# **Responses to Questions By the General Accounting Office Related to Construction of the Sunshine Skyway Bridge**

June 1984

NBSIR 84-2892

Nicholas J. Carino

Figure 2 Cross sections of main piers for cable-stayed bridge

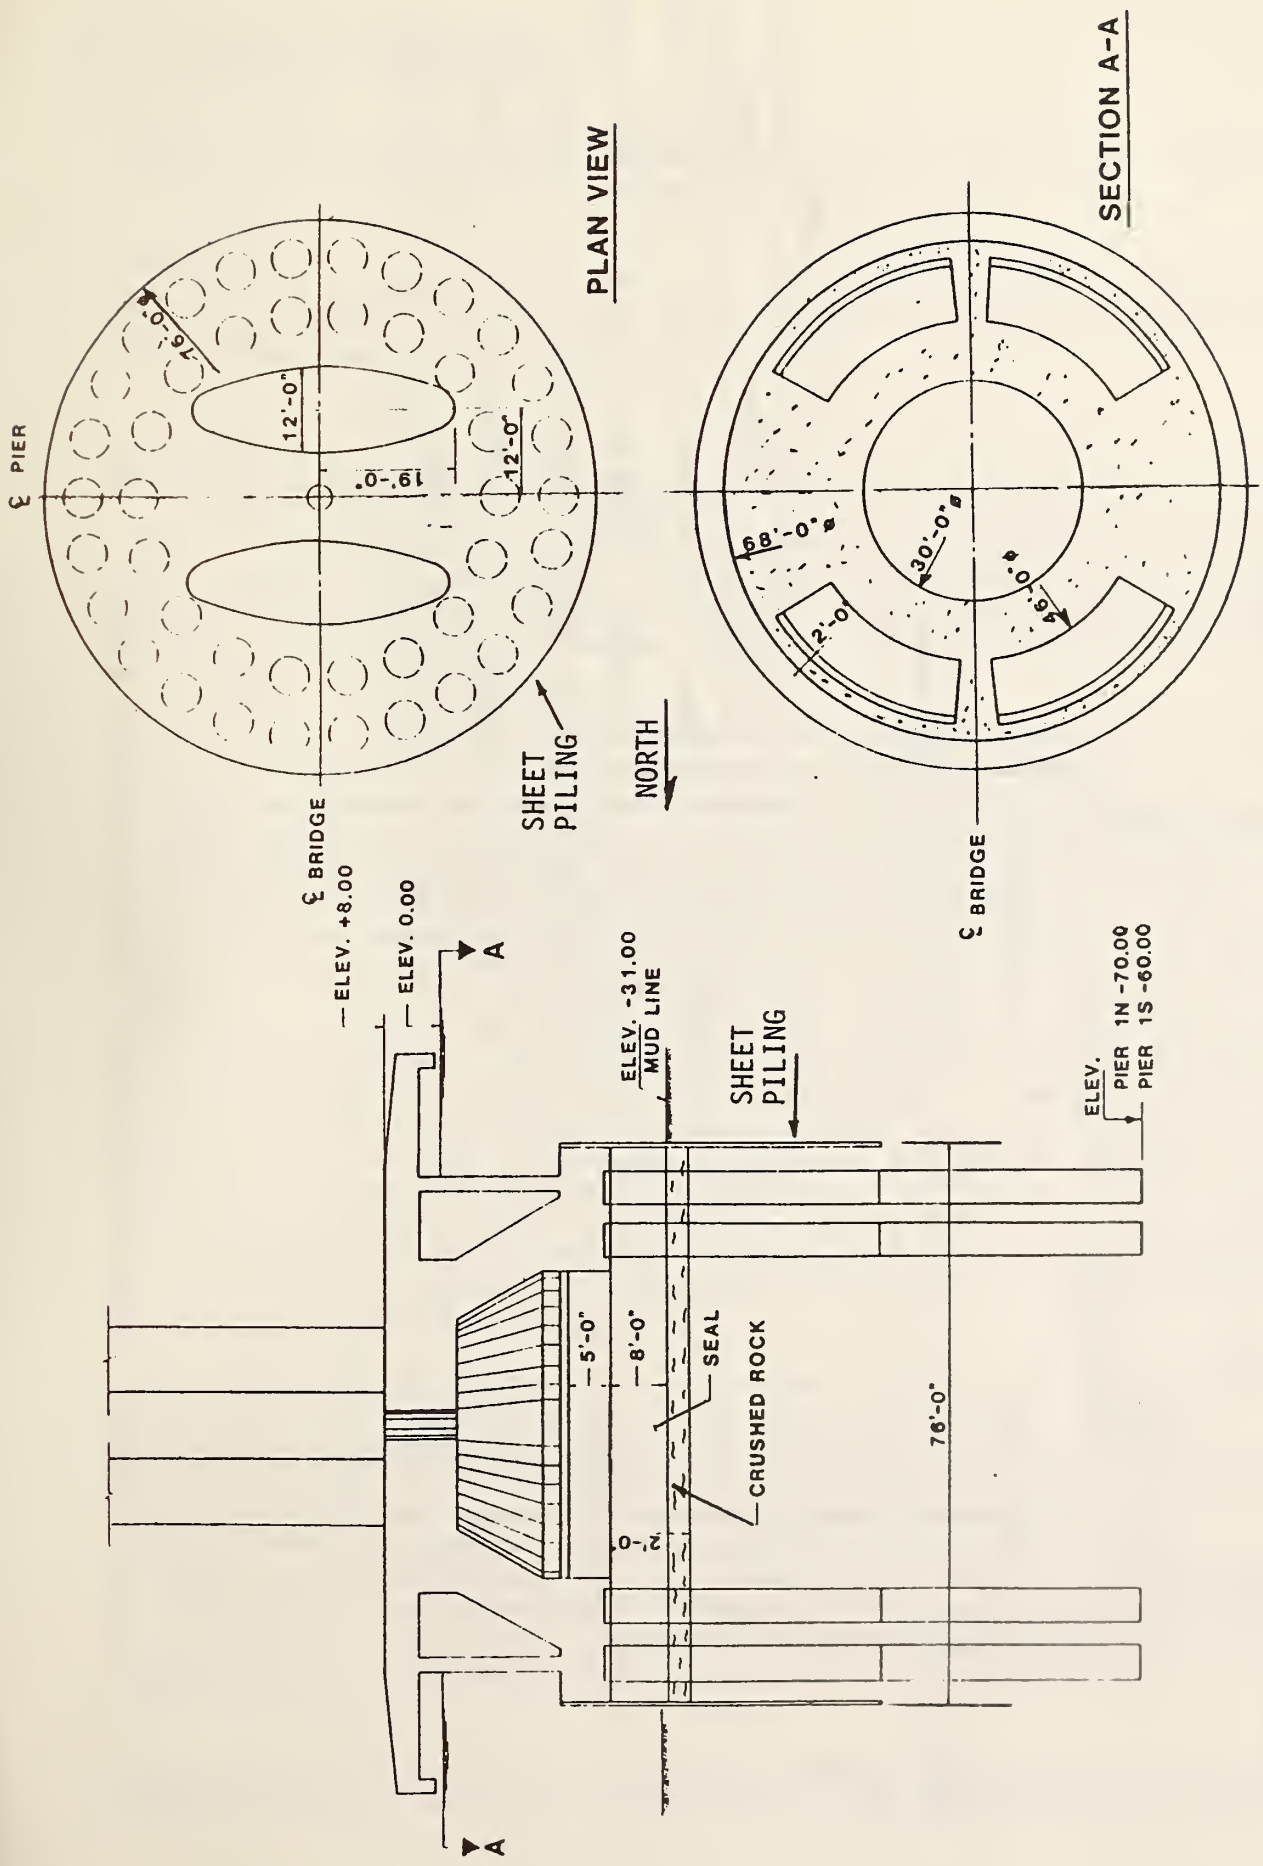
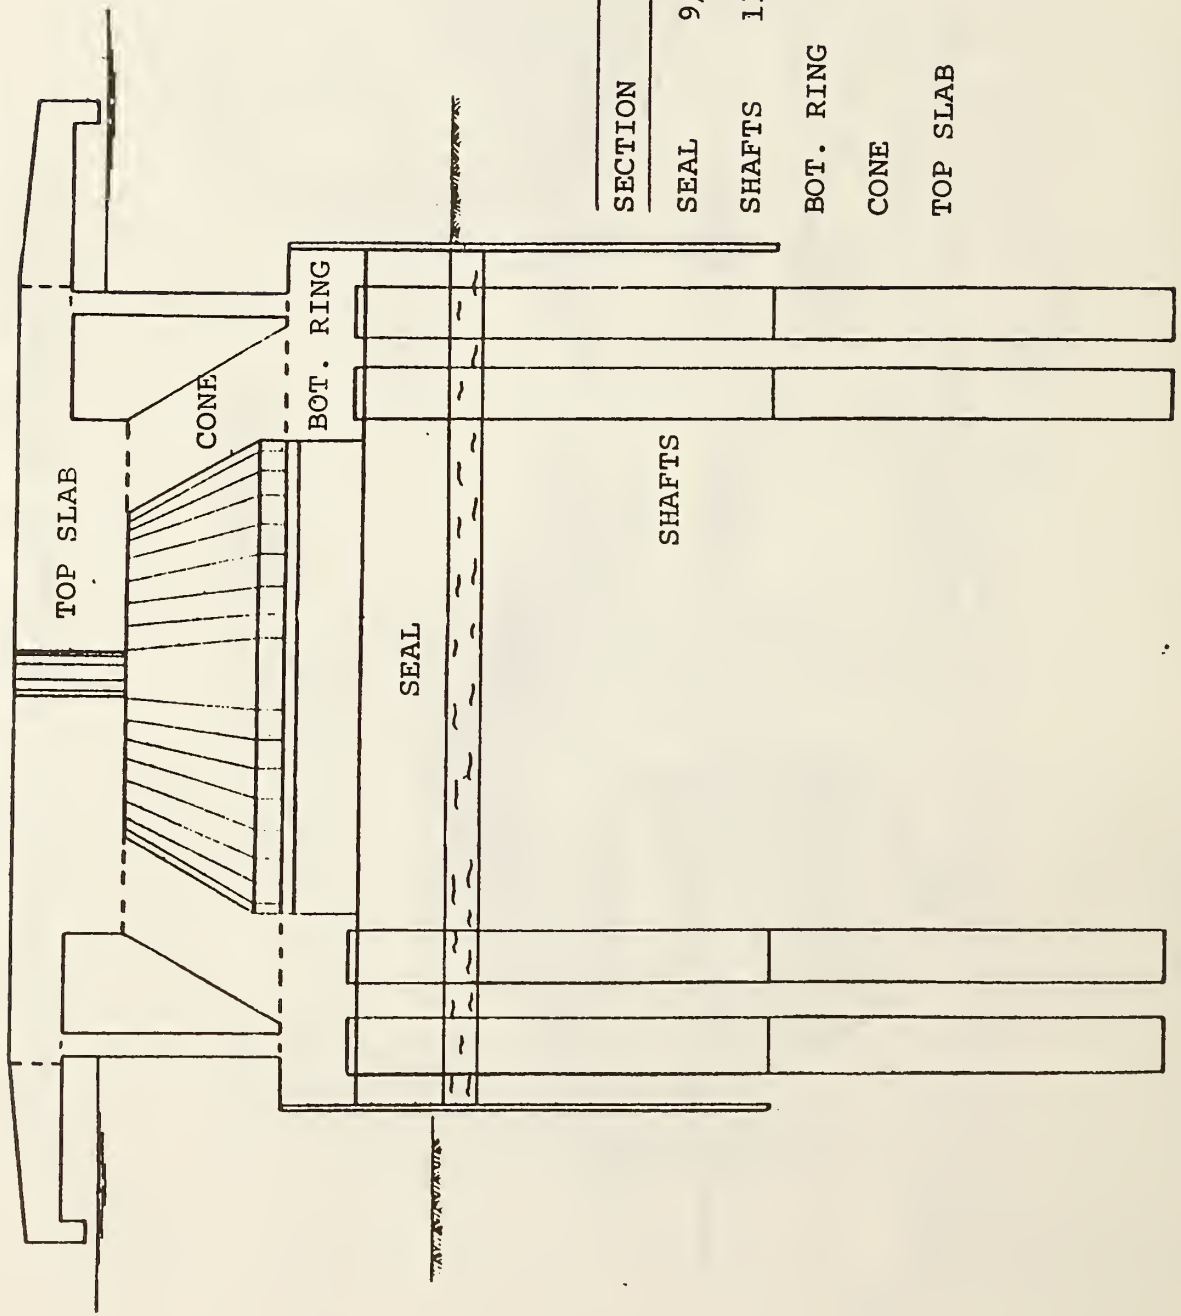
FDOT acknowledges that some of the cracks may go all the way through the cone wall. What is the significance of cracks that go all the way through the cone wall?

The cracks are not significant in terms of the structural capacity of the piers but they may be of significance in terms of long-term performance.

First, the philosophy of reinforced concrete design must be recognized. In designing a reinforced concrete member to safely carry a given external load, it is assumed that the portion of the member subjected to tensile stress is cracked and sufficient steel is provided to carry the necessary tensile loading. Hence, the presence of cracks in reinforced concrete members does not necessarily mean that structural capacity has been affected. To determine the significance, if any, of cracks in the cones it is necessary to consider the structural action of the cones and the relationship between crack orientation and load paths through the piers.

According to information provided by FDOT: "The cone acts primarily as a massive compression member... There are some local and bending effects also in the cone." This means that the cone walls carry an inclined axial force plus a bending moment. The structural drawings indicate a large number of #14 and #18 bars running in the vertical direction of the cones. These represent the reinforcement assisting the concrete in carrying the load from the superstructure down to the foundation. The circumferential bars in the cones are smaller (#8 bars) and the area of this reinforcement is 0.24% of the concrete area of a vertical section through the cone. As explained in the response to question 1.1, the amount of circumferential steel meets the minimum requirements for the control of shrinkage cracking. The adequacy of the circumferential steel to resist tensile stresses due to the external load on the piers depends on the magnitude of the circumferential stresses that may develop under the action of that load. It is our understanding that FDOT is in the process of performing a stress analysis of the piers. The results of that analysis should indicate whether the circumferential steel is adequate to carry any tensile stresses that may develop under service loads.

The cracks may have some significance in terms of the long-term performance of the piers. Specifically, the cracks may permit localized corrosion on some of the reinforcing steel. Although the bars are epoxy-coated, there are probably breaks in the coating which may have been produced during the placement and consolidation of the concrete. In addition, there could also be breaks that were produced during the placement of the steel which were not seen during the patching of the coating. If any of these defects in the coating happen to lie near the cracks, there is the possibility of localized pitting due to the presence of seawater. While such localized corrosion presents no short-term problems, it is not certain what may happen in the long-term. The basic problem is that epoxy-coated bars are relatively new products and we do not have sufficient historical records to determine the effects of small defects on long-term performance.

In summary, the vertical cracks in the cones do not appear to have any significance in terms of the structural capacity of the piers, but they may have some significance in terms of long-term durability.
